APPLICATION NO.	FILING DATE	FIRST NAMED INVENTOR	ATTORNEY DOCKET NO.	CONFIRMATION NO.
10/563,338	01/03/2006	Louis Lagler	P/4631-14	8840
2352 7590 10/02/2008 OSTROLENK FABER GERB & SOFFEN 1180 AVENUE OF THE AMERICAS NEW YORK, NY 100368403				
EXAMINER TUCKER, DANIEL P				
ART UNIT		PAPER NUMBER		
4159				
MAIL DATE		DELIVERY MODE		
10/02/2008		PAPER

Office Action Summary

DETAILED ACTION

Fig. 1 of US Patent No. 5,148,912 (Nozawa hereinafter)

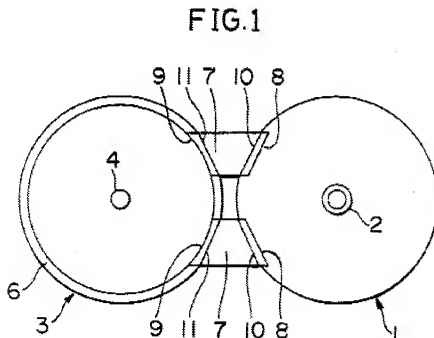
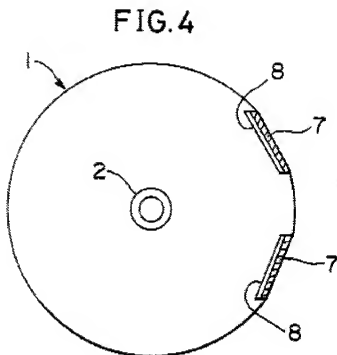
5. In re Claim 1, with reference to Fig. 1 and Fig. 4 above, Nozawa discloses:

A closure moulded in closed position with

- a body (1) comprising fixing (col. 7, lines 5-7) means to fix the closure on a neck of a bottle, and
- a lid (3), comprising a sealing mean (4) to seal an orifice (2) of the bottle,
- a snap hinge comprising a first and a second trapezoid element (7) and a first and second pair of film hinges (10, 11) each pair defining a first and a second plane (Fig. 4), the first and the second pair of film hinges (10, 11) connecting the first and the second trapezoid element (7) to the lid (3) and to the body (1), whereby the first and the second plane are arranged substantially parallel to an axis A (Fig. 4) of the closure.

Nozawa does not disclose that the body and the lid are separated by a circumferential gap.

11. In re Claim 5, with reference to Fig. 1 and Fig. 4 above, Nozawa discloses that that the film hinges (10, 11) are defined by a plane on the inside of the closure and the outside of the film hinges (10, 11) is defined by two flat boundary planes, arranged at an angle each other, and a cylindrical boundary surface having a radius.

It is implicit that the boundary planes of the film hinges be at angle to each and have a cylindrical boundary surface otherwise the closure would not open.

12. In re Claim 6, with reference to Fig. 1 and Fig. 4 above, Nozawa discloses that the trapezoid elements (7) are spaced apart by a cutout.

15. In re Claim 10, with reference to Fig. 1 and Fig. 4 above, Nozawa discloses that the closure is characterized by a cylindrical outer wall section.

Fig. 5 of US Patent No. 6,041,477 (Rentsch et al. hereinafter)

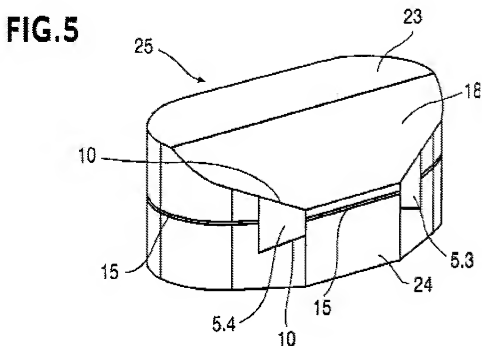
6. However, with reference to Fig. 5 above, Rentsch et al. discloses a closure whereby the body (24) and the lid (23) are separated from each other by a circumferential gap (15).

7. Thus it would have been obvious to one having ordinary skill in the pertinent art at the time the invention was made to have modified the closure of Nozawa to have a circumferential gap as taught by Rentsch et al. in order to achieve the predictable result of separating the body from the lid.

Fig. 7 of Rentsch et al.

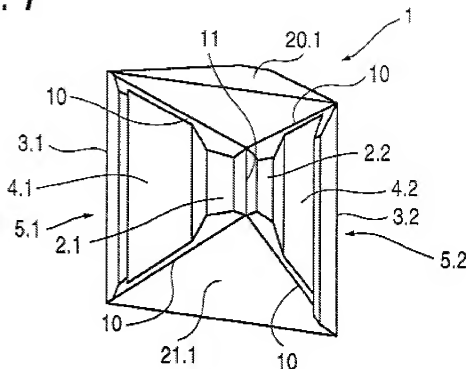
13. In re Claim 7, with reference to Fig. 7 above, Rentsch et al. discloses that the trapezoid elements (5.1, 5.2) are connected by a thin film hinge along a shorter edge (11).

Fig. 3 of US Patent Application Publication No. 2002/0079282A1 (Harrold et al. hereinafter)

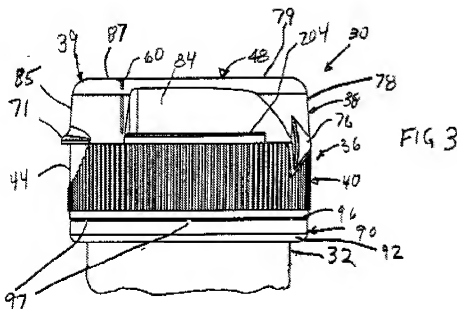
17. In re Claim 8, with reference to Fig. 1, Fig. 4, and Fig. 5 above, Nozawa in view of Rentsch et al. discloses the claimed invention except for tamper evidence means.

18. However, with reference to Fig. 3 above, Harrold et al. discloses tamper evidence means (90).

19. Thus, it would have been obvious to one having ordinary skill in the pertinent art at the time the invention was made to have modified the closure disclosed by Nozawa in view of Rentsch et al. to have tamper evidence means as taught by Harrold et al. in order to achieve the predictable result of indicating if the closure had been tampered with.
